Your ref: Tilbuster 2 Solar Farm (SSD-69799460)
Our ref: 12636761

16 June 2026

Tilbuster 2 Solar Farm Response to Submissions Report – Request for Additional Information

Annexure A – Flood Maps

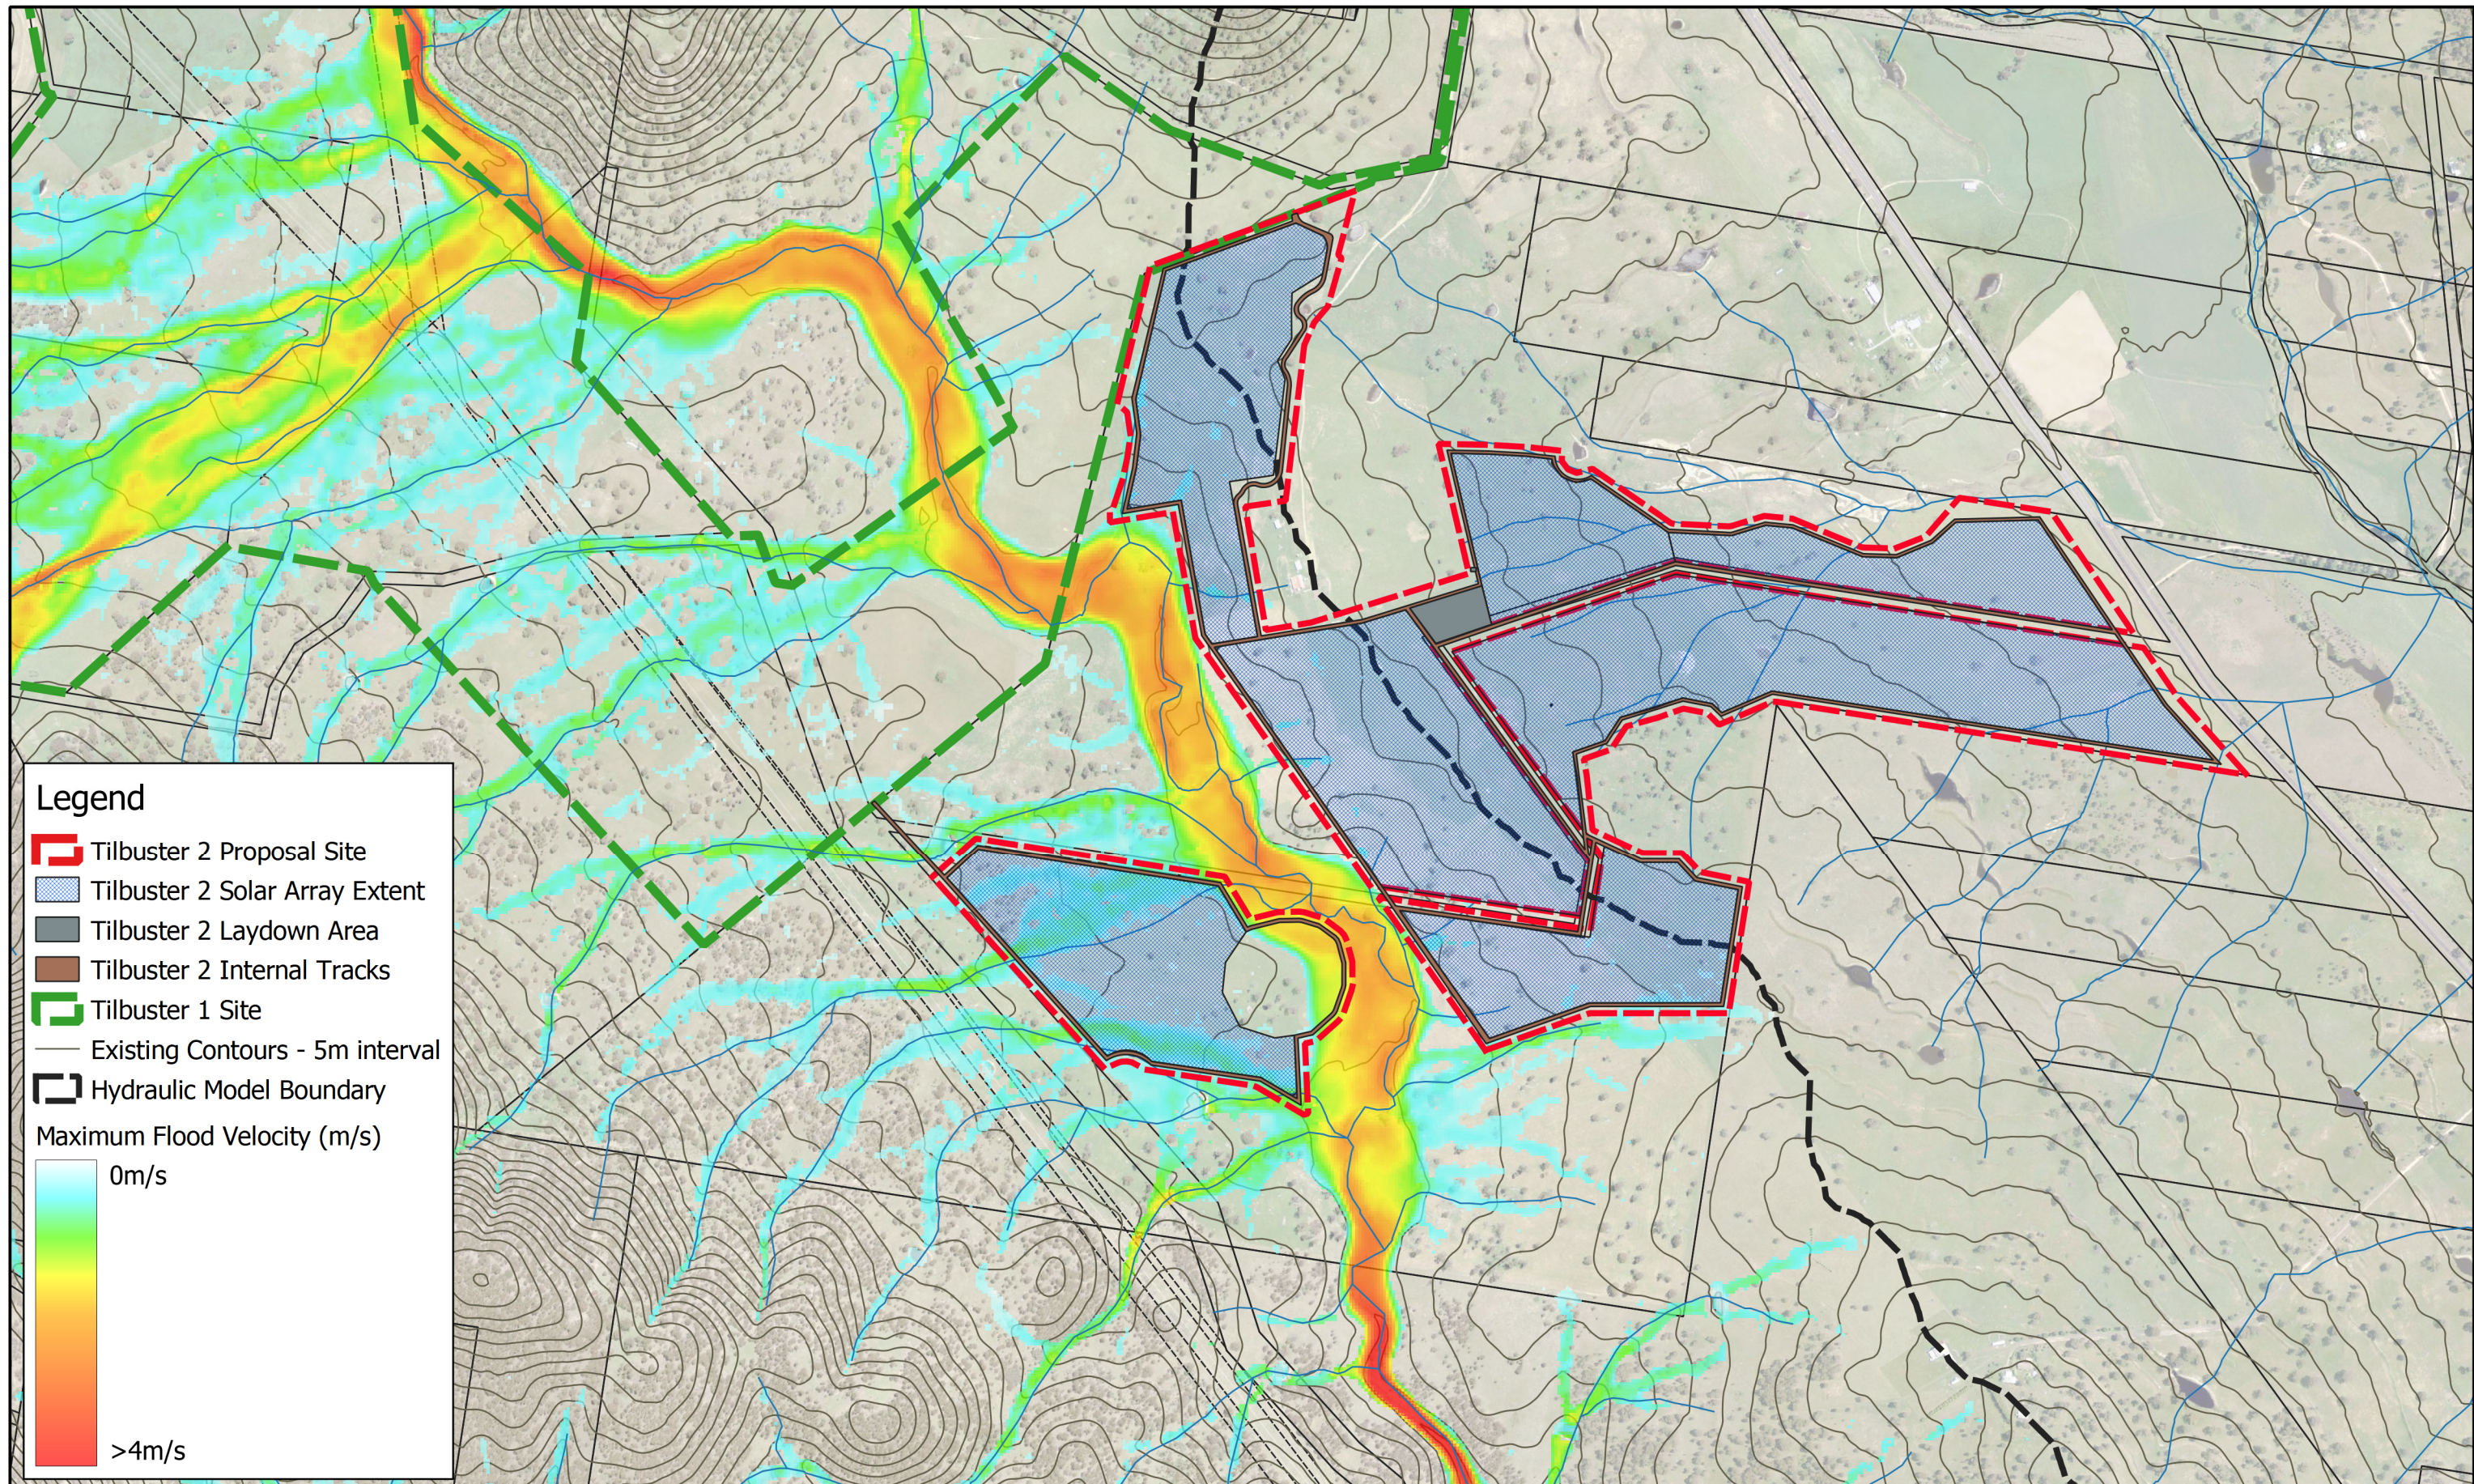
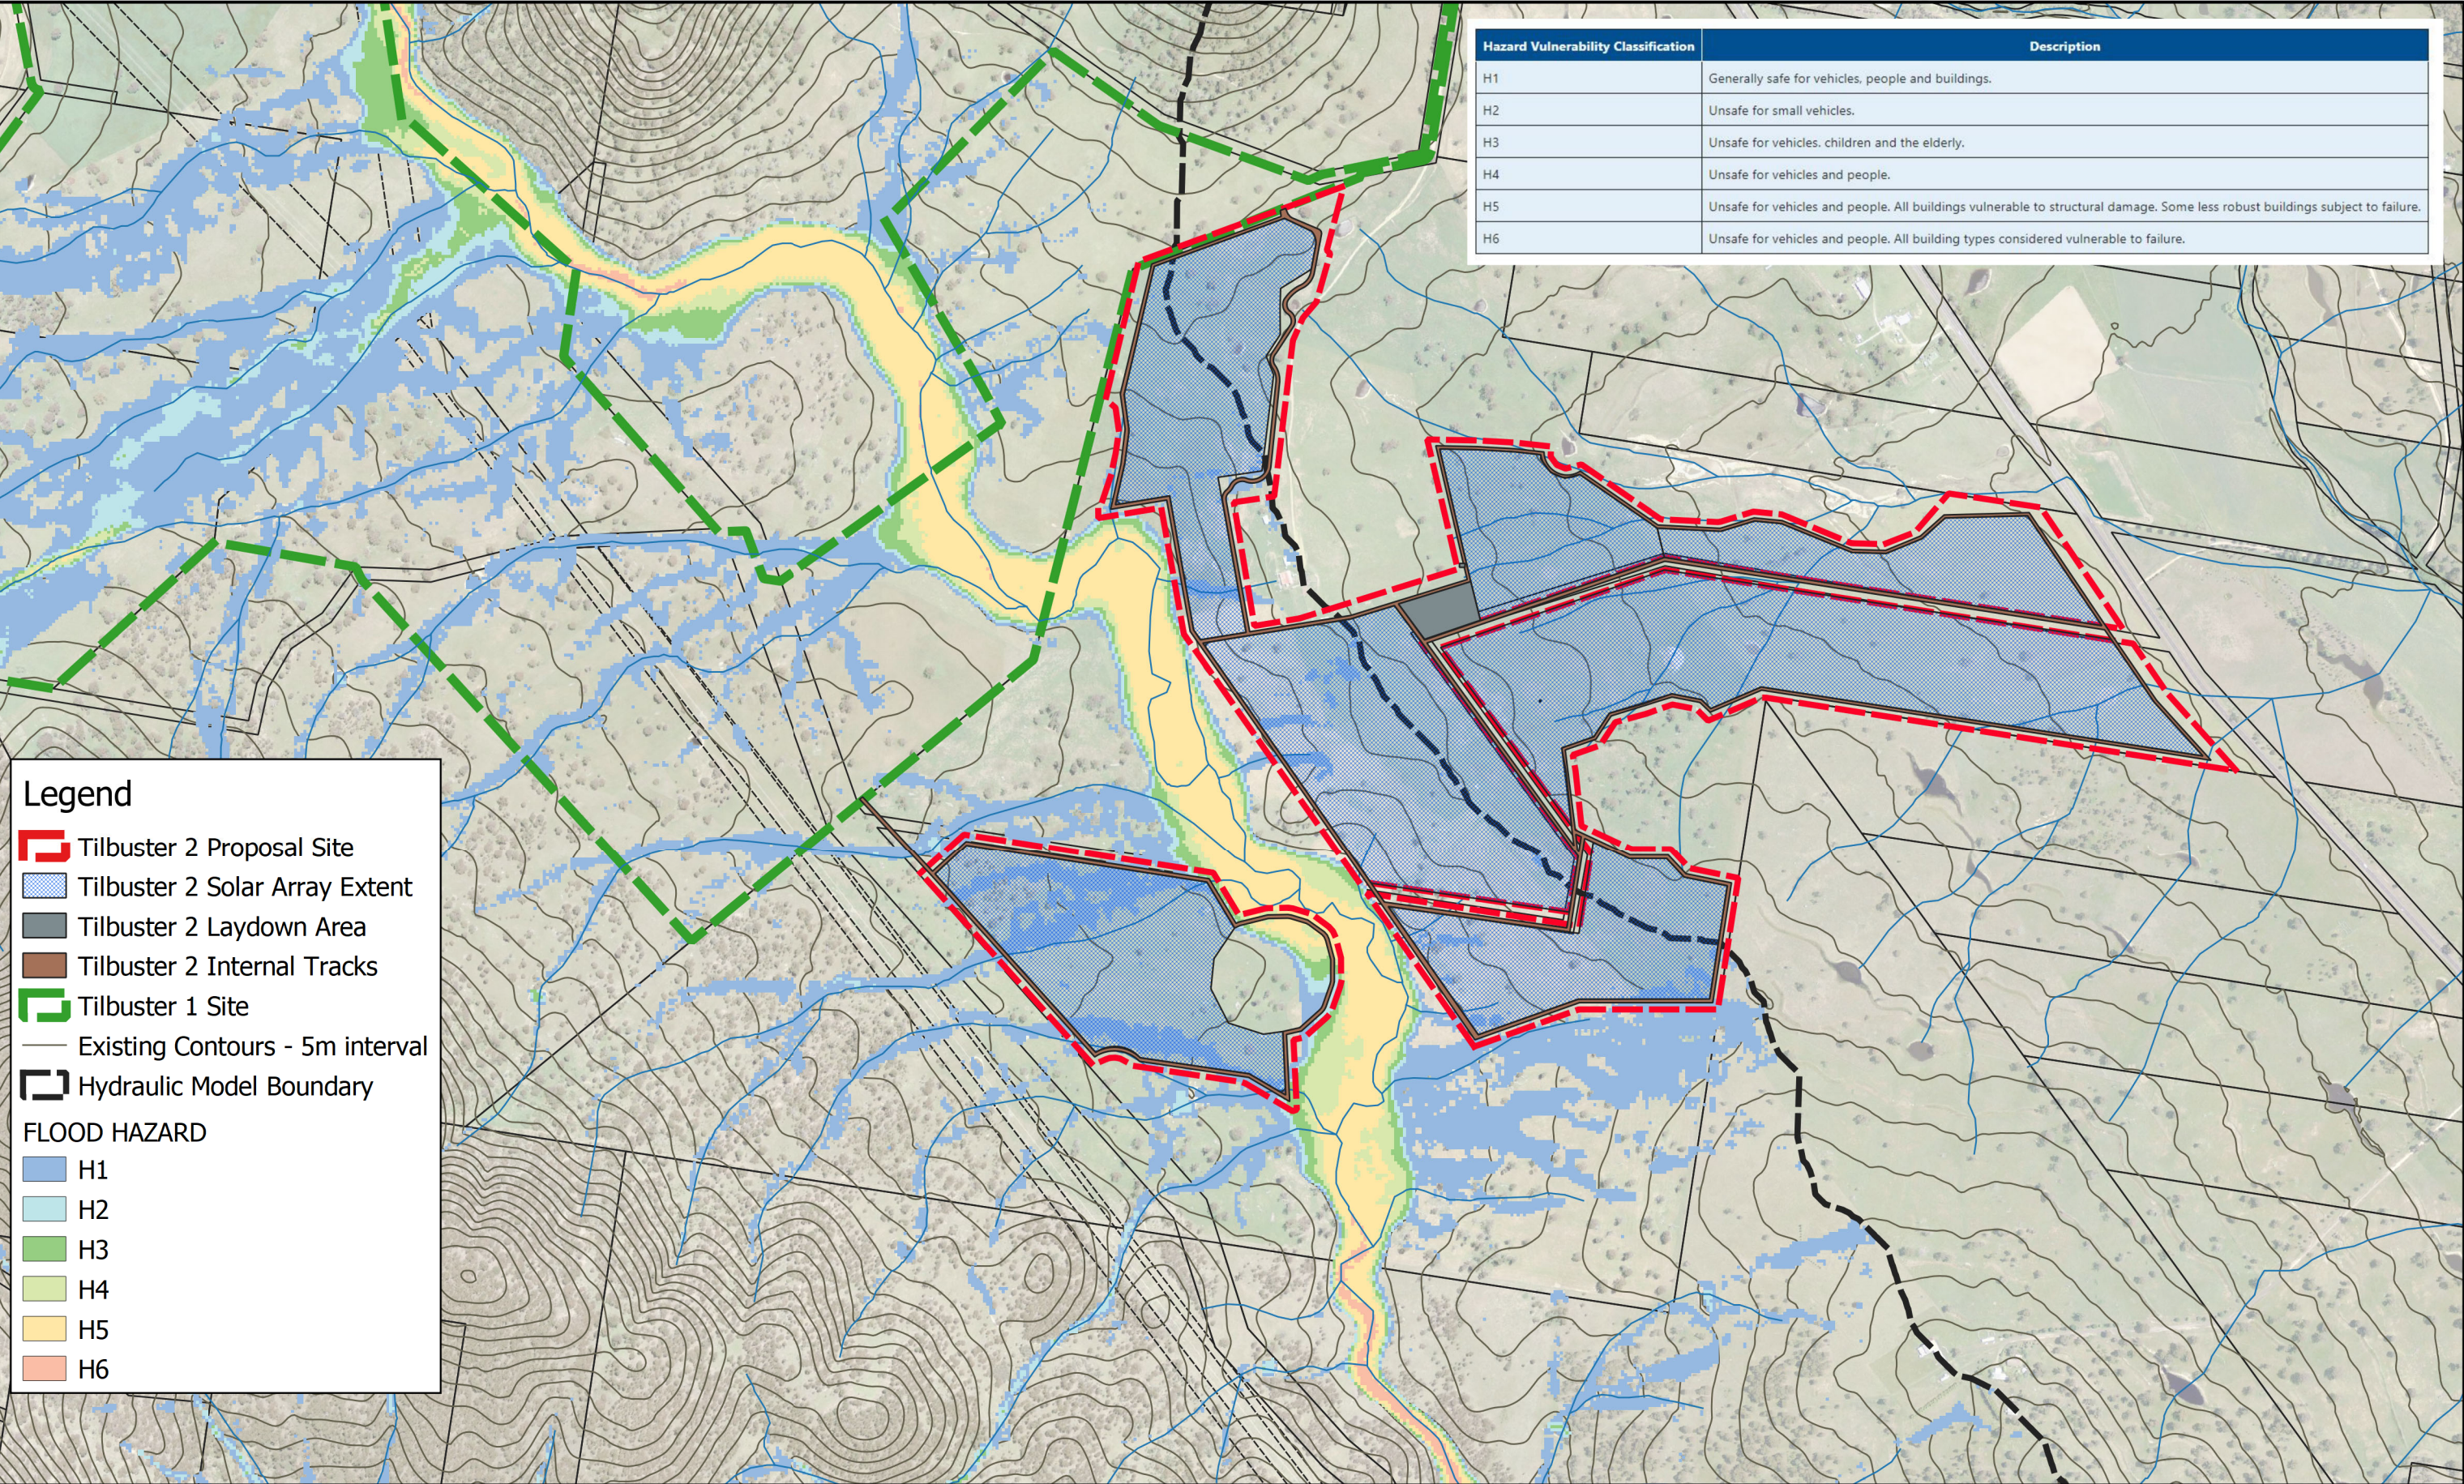
The Department of Planning, Housing and Infrastructure (DPHI) have requested pre and post development flood mapping for the proposal site. This is provided in Attachment 1.

The Tilbuster 2 site layout has been overlaid on the pre-development flood mapping prepared for the Tilbuster project and a copy of this mapping is included in Annexure A.

The figures show that the extent of the proposed solar array for Tilbuster 2 is typically clear of the extent of fluvial flooding associated with Duval Creek for the 5% AEP and 1% AEP events. Some areas on the western side of Duval Creek are impacted in the PMF event; however, these are generally outside the H6 hazard in that event. Otherwise, minor overland flooding is shown to occur through the solar arrays west of Duval Creek over first and second or watercourses (ephemeral depressions) in this area, however these flows are of low hazard (H1-H2) in all events.

Given that the proposed solar arrays are to be largely located outside areas of high flood hazard the proposed works are unlikely to result in an adverse impact on flooding within Duval Creek provided that the flood management recommendations contain in Section 6.0 of the Tilbuster Report are applied to this development.

Figure 1-3: Mapped estimated extent of landform shared by PAD 1, 21-1-0353 and 21-1-0354.

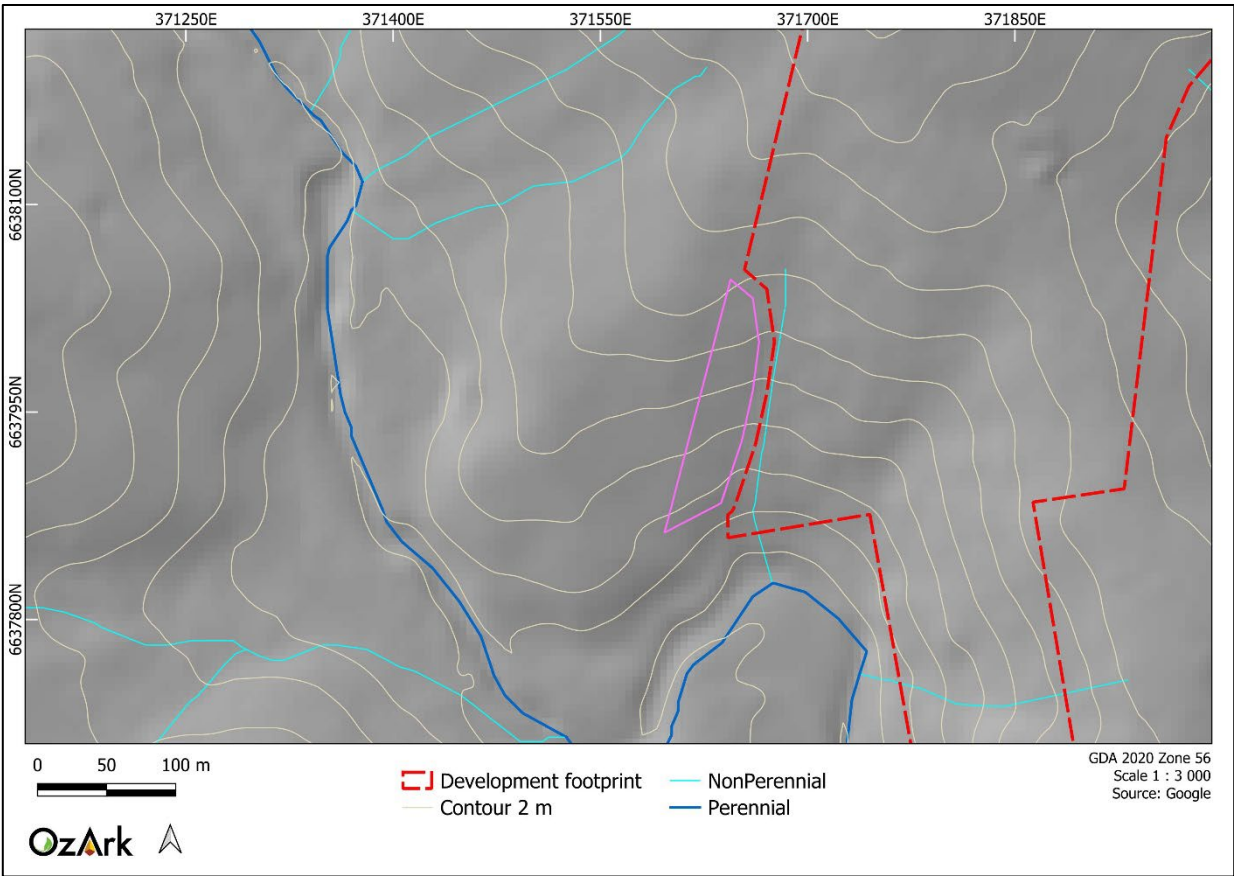
The ACHAR indicates that site and PAD boundaries were primarily based on landform classification. However, inconsistencies exist between site descriptions and mapped landforms. For example, 'Tilbuster Stage 2 PAD 4' (AHIMS 21-1-0587) is described as being on an elevated rise/localised crest (Table 6.5) yes Figure 6.3 places it within an area mapped as a gentle slope.

Please clarify the methodology used to define site / PAD boundaries in accordance with Requirements 6 and 7 of the Code of Practice for Archaeological Investigation of Aboriginal Objects in NSW ('the Code of Practice'; DECCW 2010). Where slight elevation changes within broader landform units were used to define boundaries, this should be clearly described and supported by additional mapping (e.g., fine-grained contour mapping to identify microtopography).

With this understanding of the landform, two observations can be emphasised. Firstly, that the test excavations at 21-1-0353 and 21-1-0354 undertaken for Tilbuster Stage 1 have tested the same aspect of the landform and provided low density subsurface results with nil conservation value, results which can confidently be extrapolated to PAD 1. Secondly, that the development footprint, which has been redesigned to lie 10 m east of PAD 1, is situated on the gentle slopes east of the local spur and does not encroach on the level part of the landform associated with archaeological potential.

The detailed landform mapping provides confidence that the PAD 1 extent is attached to distinct albeit subtle manifestations of the landform, specifically a low, local spur overlooking Duval Creek. This clarification of the PAD's relationship to the landform expands on and reiterates the ACHAR's conclusion that test excavation is not warranted as ground disturbing works will completely avoid the area of identified archaeological sensitivity, the definition of which is evidence-based, as presented.
